SEATTLE ARENA

DOWNTOWN DESIGN REVIEW BOARD | RECOMMENDATION

PROJECT NUMBER: 301 4195 | 1700 FIRST AVENUE SOUTH

2.0 RESPONSE TO INITIAL RECOMMENDATIONS | 15

Event Level Detail | [August 6, 2013]

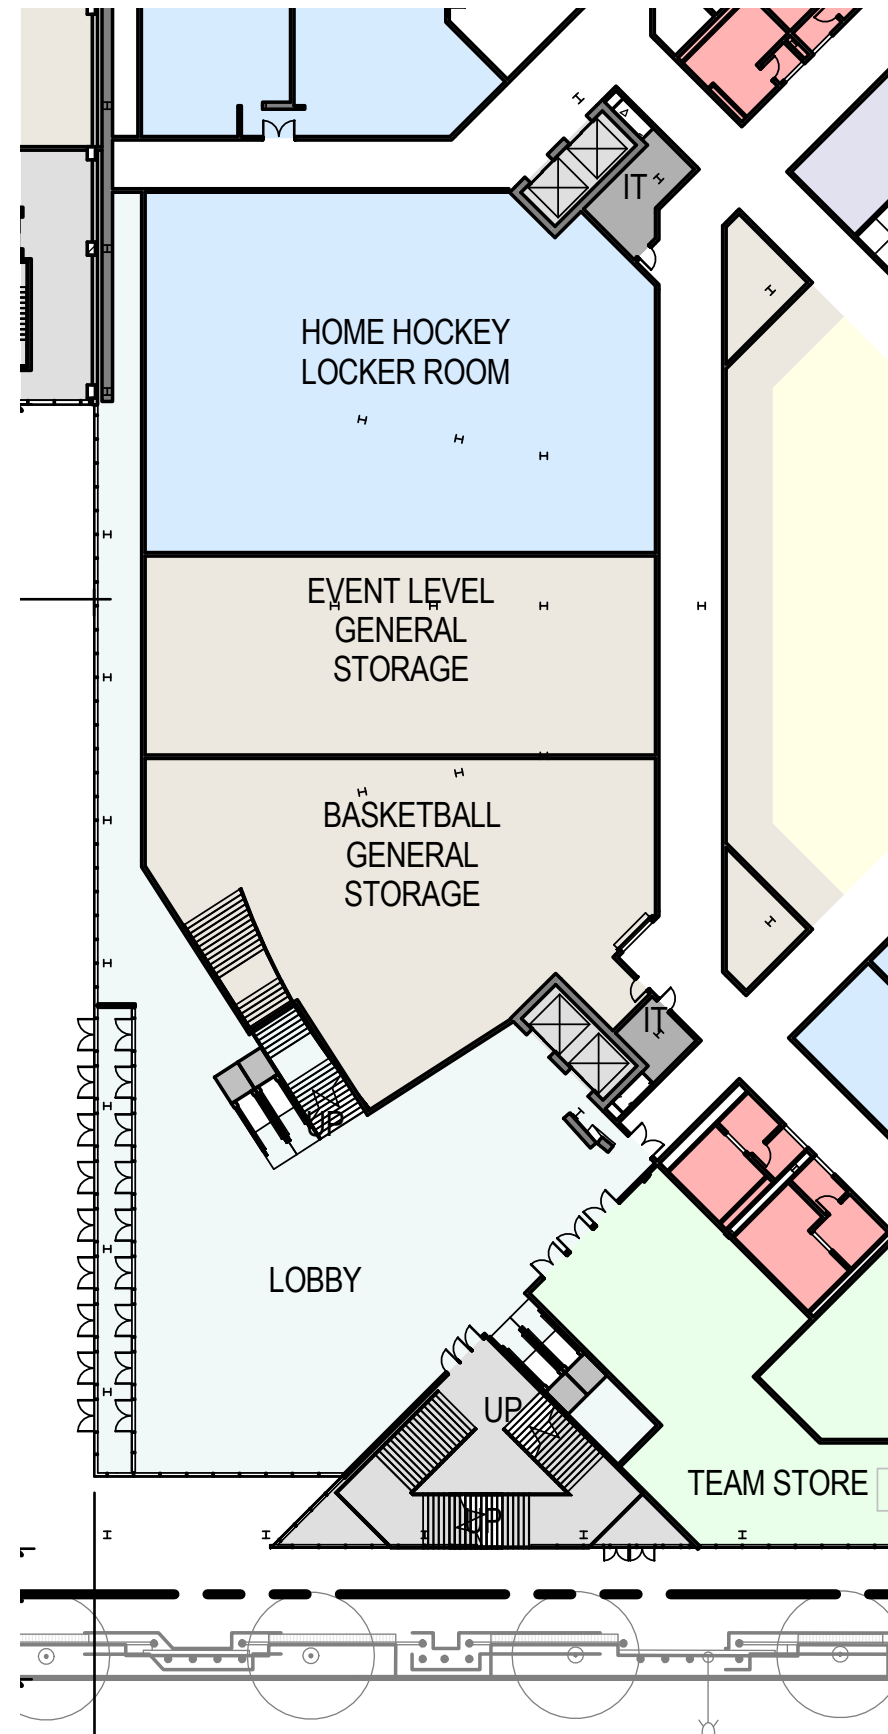
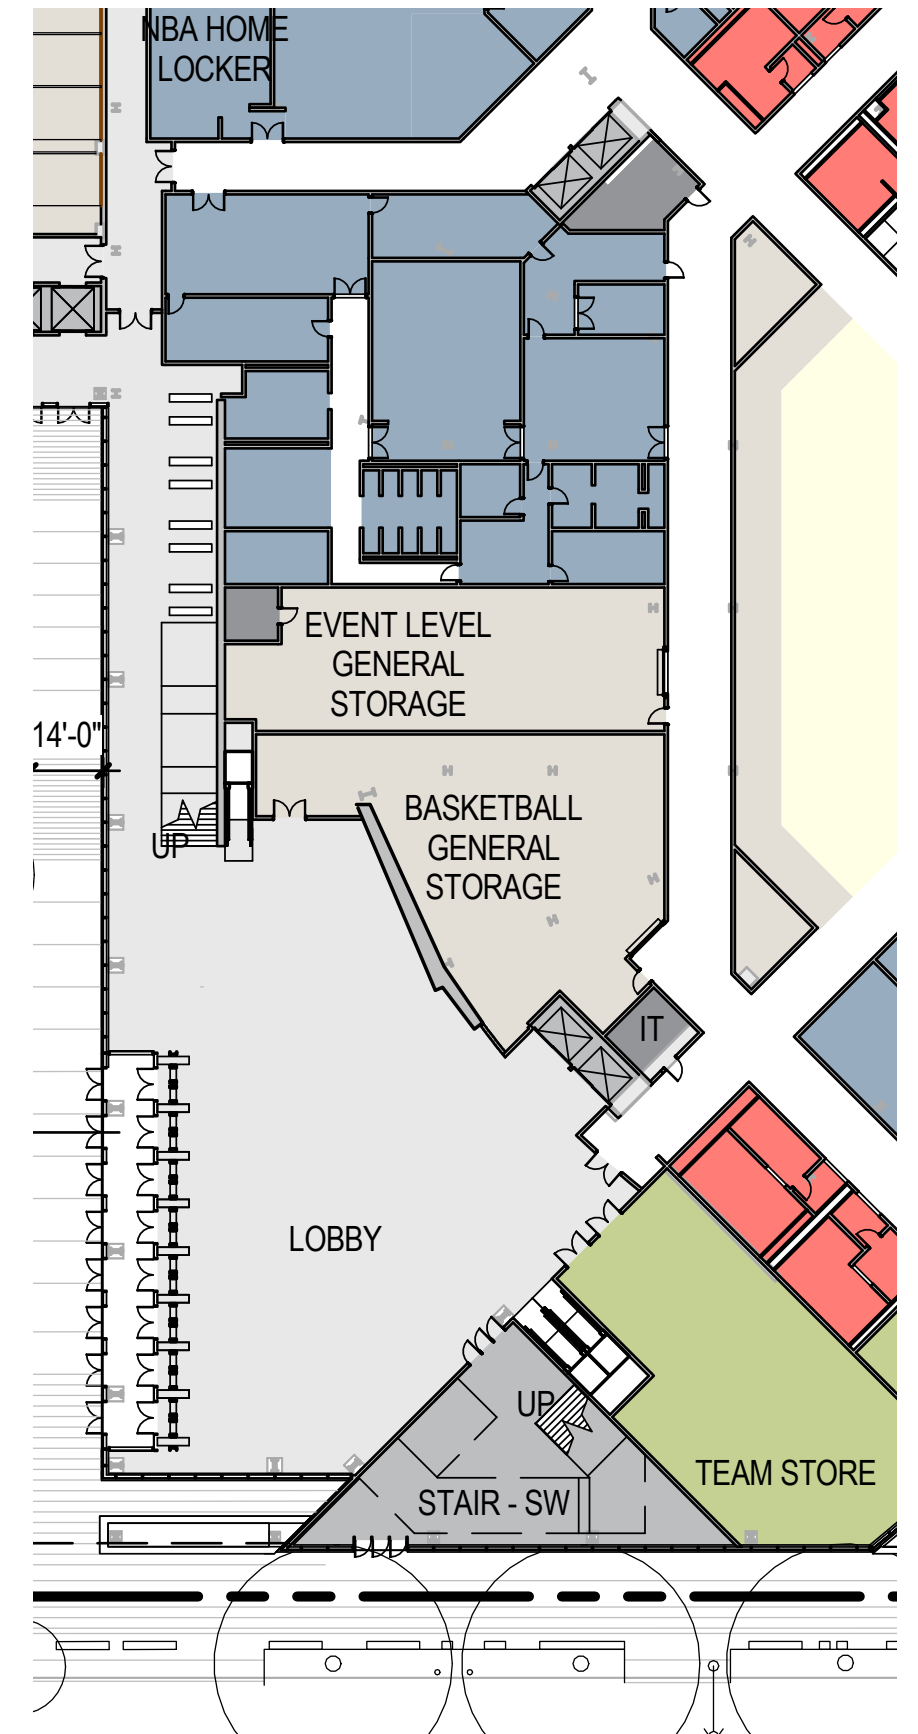
1) The purported transparency of the sizable stair triangles and all other ground level uses should be fully explained. The storage functions behind the north glass wall facing the plaza are not activating. The two lobbies appear narrow and constraining for pre-event screening and large exit surges, especially since the former north exterior stair is no longer available (the lobbies have gotten smaller, not larger since that was deleted). Provide diagrams and capacity analysis of how 20,000 people move into and vertically through these two lobbies and the rest of the concourses. [C-1, C-3, C-4]

The storage functions are pulled away from the exterior wall to provide a circulation area from parking. The walls will be treated with materials which extend the plaza in as well as an opportunity for graphics activating the space visually. The triangular stairs serve two purposes. First, the form directs flow from the street directly into the facility and focuses toward the object. The triangular stairs are transparent from the exterior allowing views into the circulation elements. The opaque walls on the interior of the stair element are opportunity for super graphics. The lobbies have been studied for entry and exit flow capacity and they are right-sized and work with the queuing areas in the plaza.

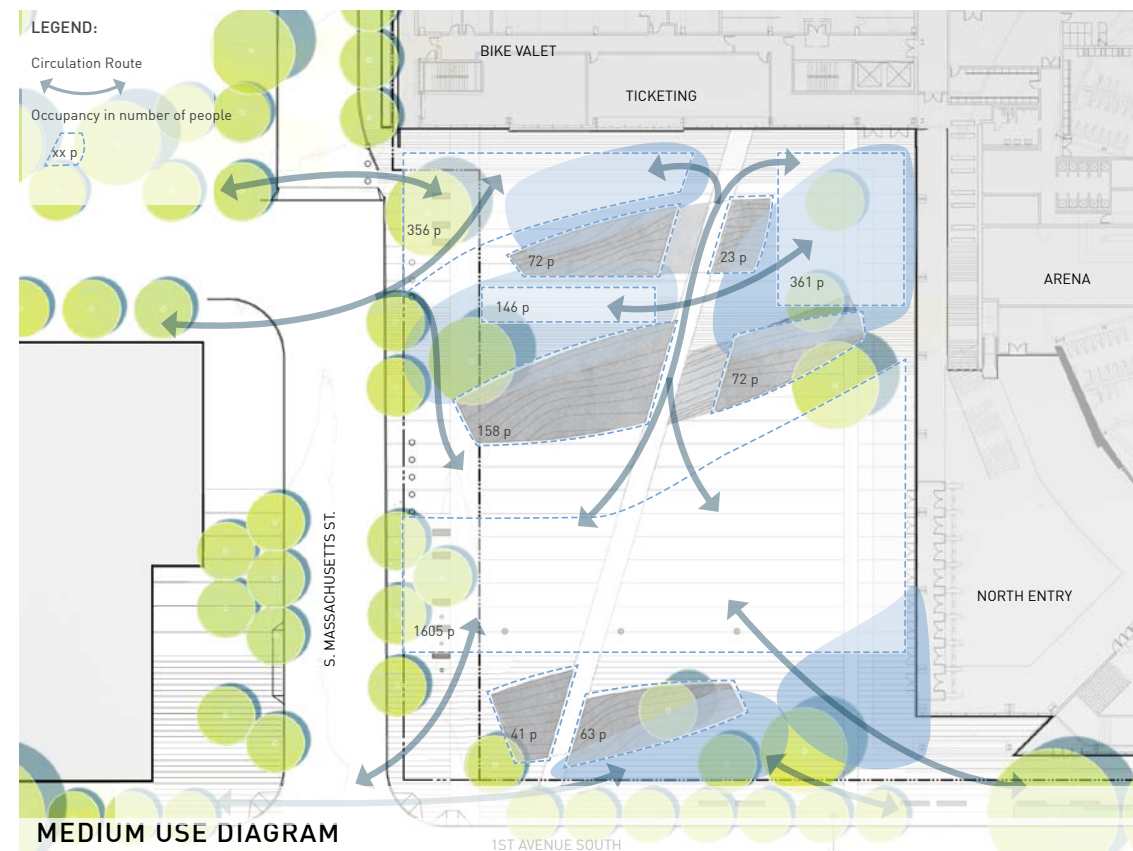
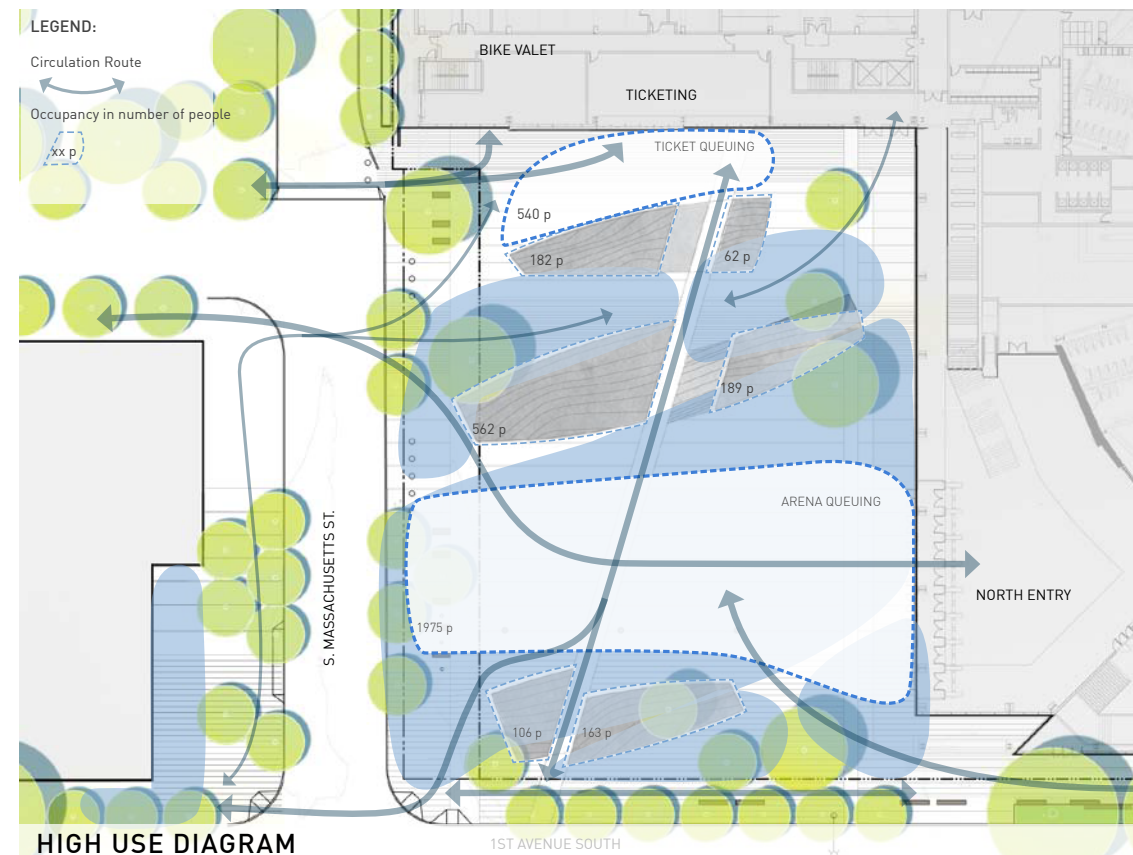
1) Provide scenarios of different uses for the plaza and adjacent public right of way, including full capacity event, public event with arena closed, and various other options. Include event queuing needs, screening, and how the Mariners plaza, north side of Massachusetts, and Occidental Street might integrate.[B-3, C-4, D-1, D-2]

The plaza and adjacent public right of way has been evaluated for a range of uses and use levels with objectives including:

- Maximize flexibility of use.
- Develop a public plaza which is comfortable, works and attracts users during events and for everyday use.
- Respond to the Occidental Street axis and Mariners Plaza and the potential for coordinated events and activities to the north.
- Provide for ease of pedestrian movement during any use level.

The design has been refined in response to the evaluation.

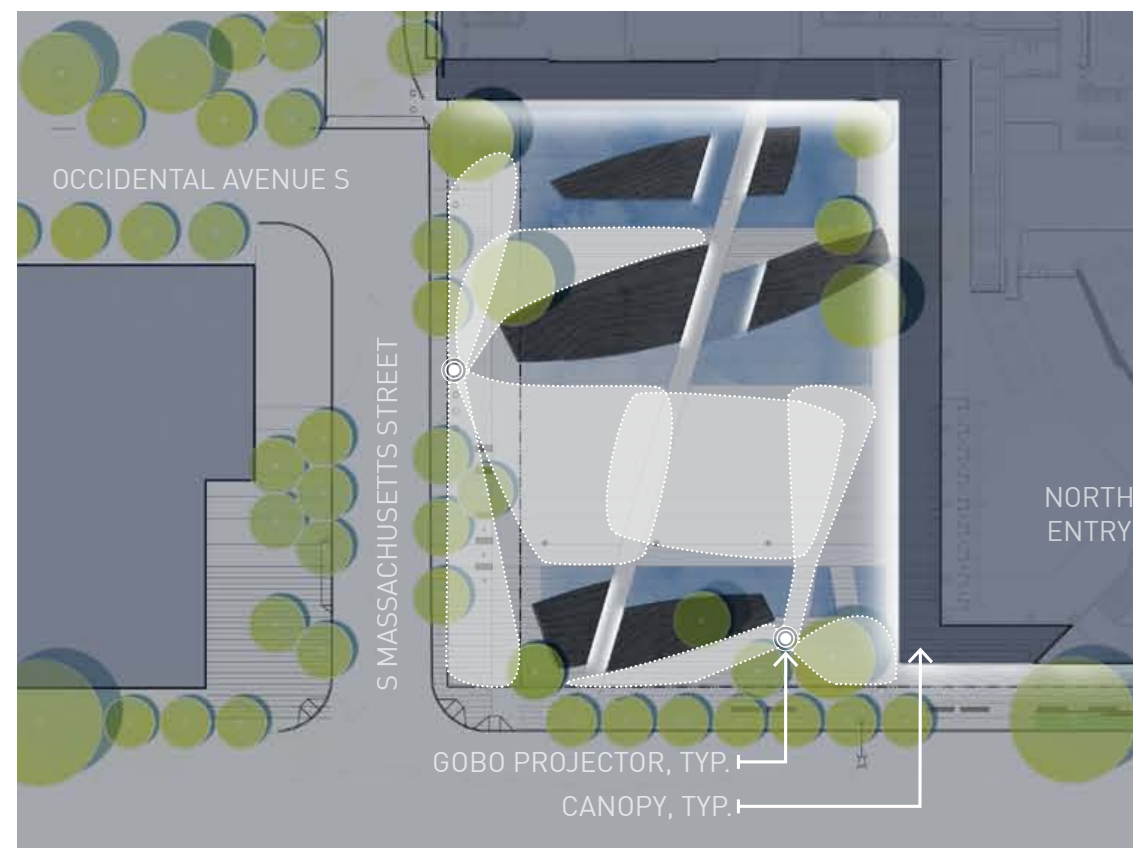
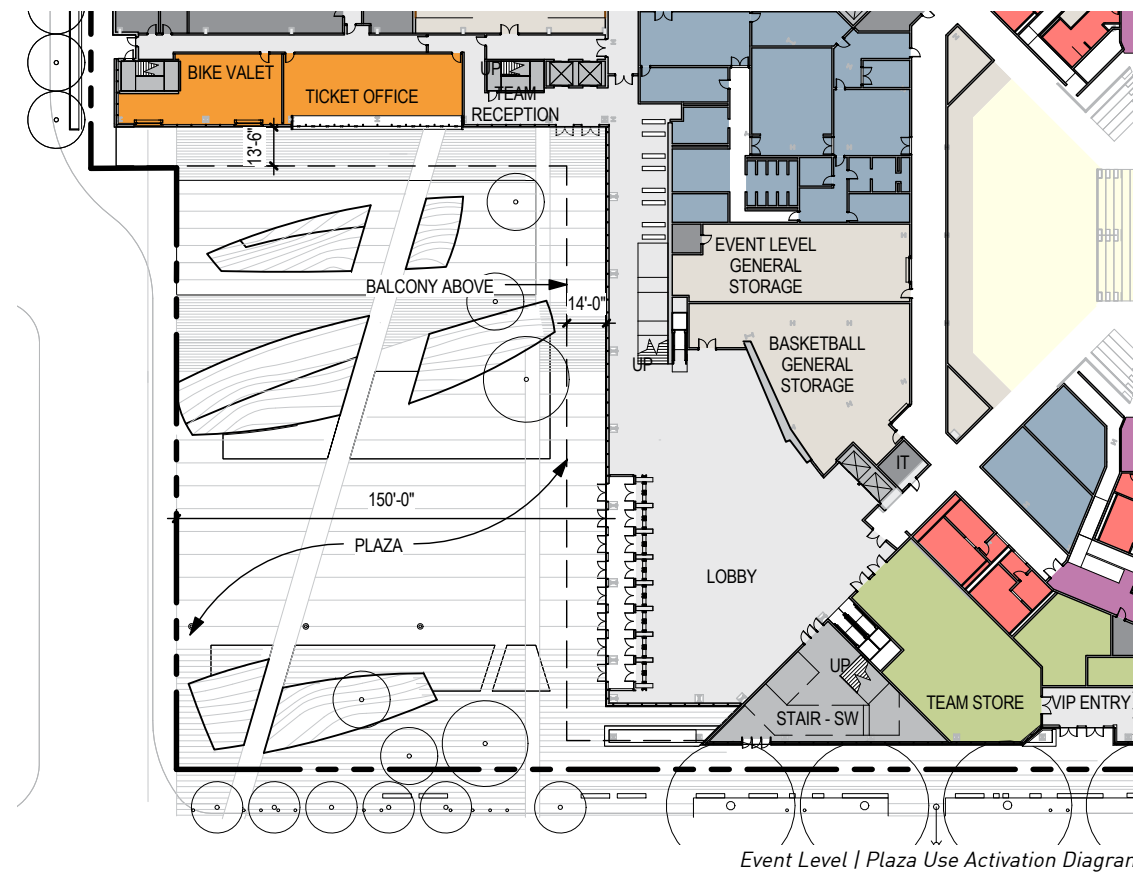
2) Consider more activating uses along both building edges of the plaza; the bike valet and ticket offices have limited activation times, and the deep plaza corner is far from adjacent streets for routine patrolling and surveillance. Provide lighting concepts.(C-3,D-5,D-6)

As noted in C.3 the shift of raising the building out of the ground provides some challenges with activating uses at the ground floor. The entry to the training facility is located along the east side of the plaza providing an active use. The plaza itself provides much needed open space in the area and can be an active space during the work day. The lighting concept is to provide relatively brightly lit areas at queuing and gathering locations and a lower level of light at the drumlin objects and intermittent water features consistent with the idea of the natural landscape metaphor and to enhance the reflection of the building in the water features.

Plaza Water Diagram

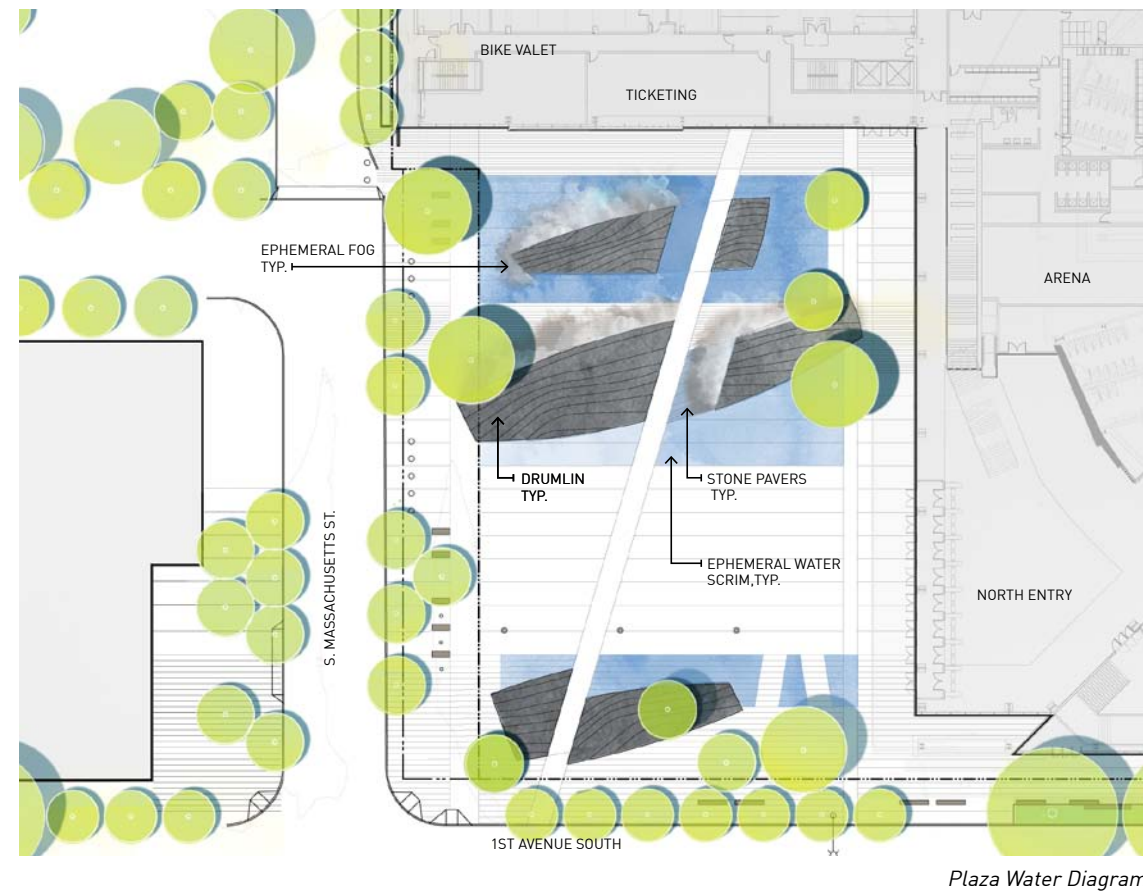
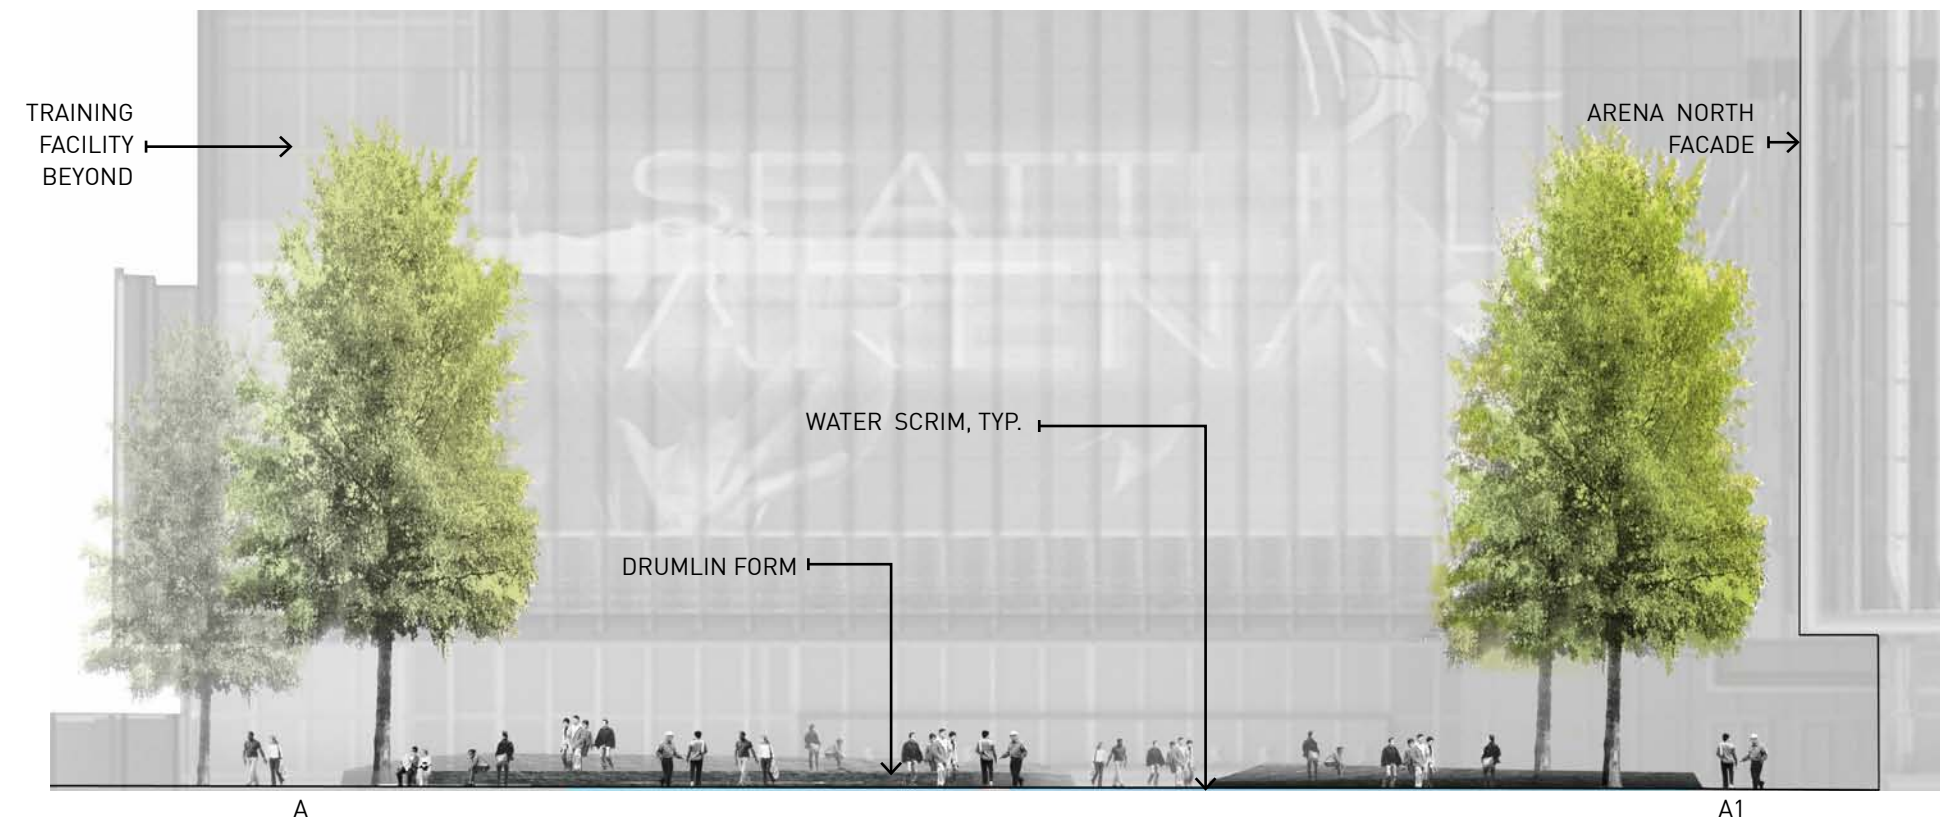
3) Approach the plaza design as a destination work of environmental art, with drama and appeal at all times. The stage, drumlins and geological metaphors are promising, but the water feature and various regulating lines need to be worked out with the building uses and practicalities. (A-1, D-1, D-3)

The plaza design uses the integration of fixed abstracted drumlins and trees as the major elements on a taught paved plane referencing the historic tide flats. The ephemeral use of calm scrims of water expands and contact in relationship to use levels. The sheets of water are designed to reflect the sky, city and arena, responding to a constantly changing environment. Mist emits from the eastern sides of the low dark stone drumlins in reference to the seasonal mists on Puget Sound lowland tide flats and inlets. The drumlins are low and designed for active use and appropriation. Lighting augments the mystery of the drumlins and water by highlighting the major pedestrian entry expanse and the washing the pavement at the edge of the building with light.

All are coordinated with use levels and natural pedestrian movement. The plaza design is intended to be a memorable destination as part of the gateway into the district and central city.
